PRCP AMENDMENT APPLICATION

Summary of Changes between current approved version (V2) and proposed amendment.

Supporting Information for Application Form

Figure 1 Current RA5 (grazing) area

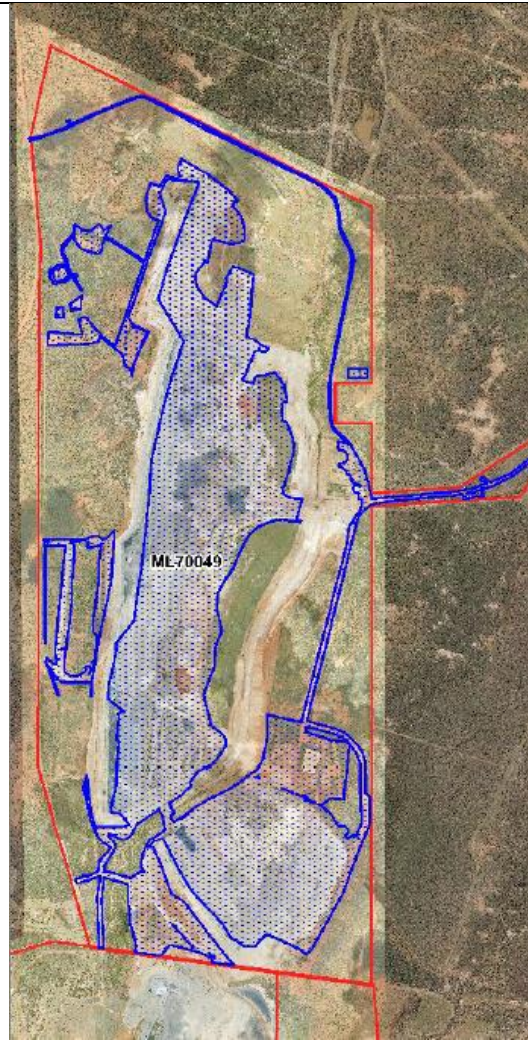
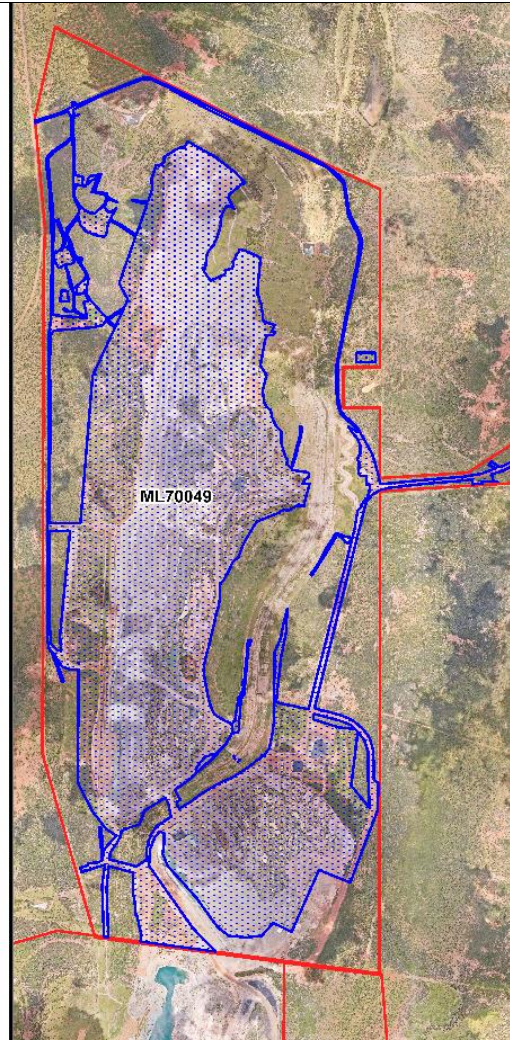
After consultation with the present background landowner of Yongala, it is proposed to alter the final land use of an area of Native Bushland Corridor to Grazing. This is primarily the area of battered down highwall of Y Pit. In order to facilitate the grazing land use, the slope will need to be reduced from 25% down to 15% and capped with 1 metre of Permian spoil (if not constructed in existing Permian material). The flatter slope will reduce the risk of erosion and be more appropriate for cattle to utilise and access.

In order to reduce the slope of the battered down highwall, the new crest will be moved to the west, increasing the area of RA5 (grazing) from 617.3 ha to 795.2 ha. This area includes a small buffer to alleviate the requirement for PRCP schedule amendments should minor boundary/design changes be required. The area of RA6 (native bushland corridor) will reduce from 137.3 ha down to 39 ha in Yongala.

Figure 3 Current RA6 (native bushland) area

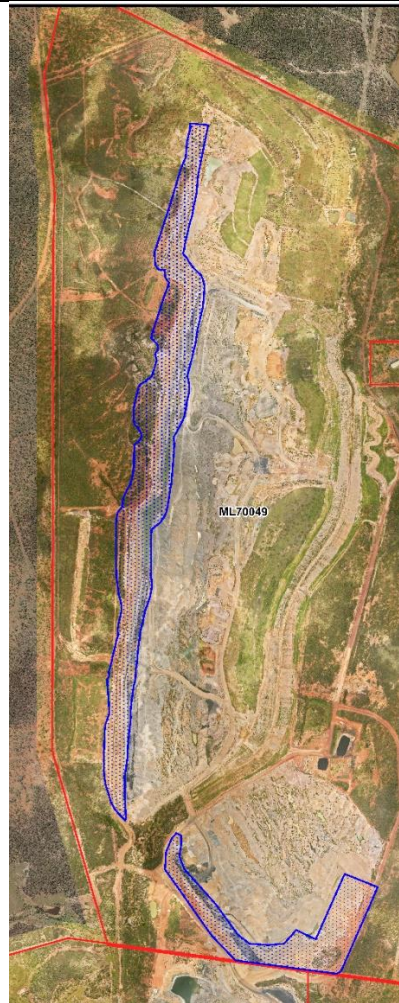
- Native bushland removed from Y Pit and moved to RA5 (area loss). The area in question that was lost to RA5 now results in the remaining area of RA6 not commencing until 2027, as was originally proposed for this F pit area. F pit native bushland boundary modified (area gain).
- 15% highwall design does not require NBC.
- Actual boundary revised to be reflective of on ground areas.

Figure 9 Current RA 4 area

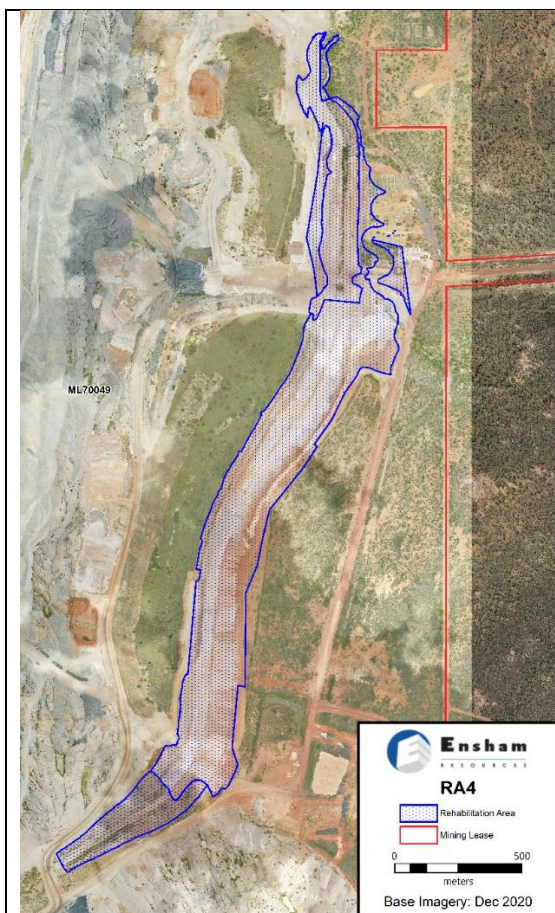
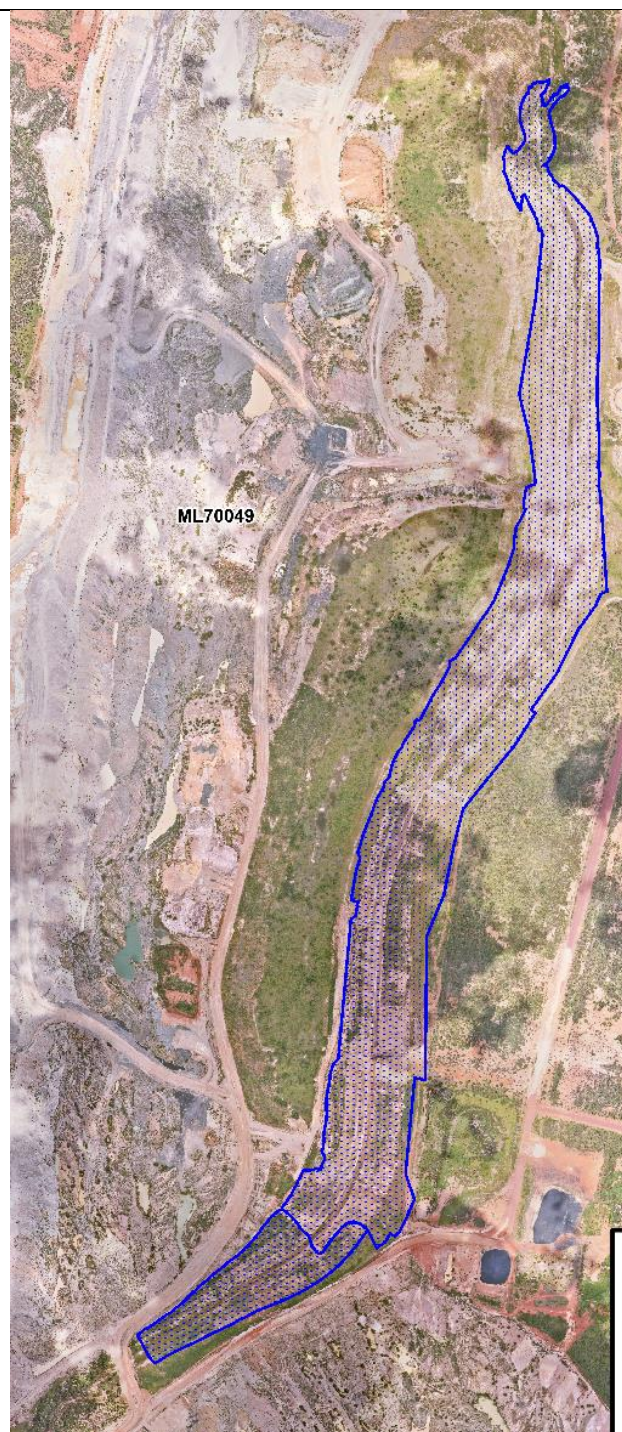
- Boggy Creek diversion areas (RA4) moved to RA2 (area loss).
- Boundaries were revised and realigned to suit where grazing land is located beyond the diversion crest. A dam originally linked to the

diversion has been backfilled as per water licence conditions to natural ground level and is now suitable for grazing.
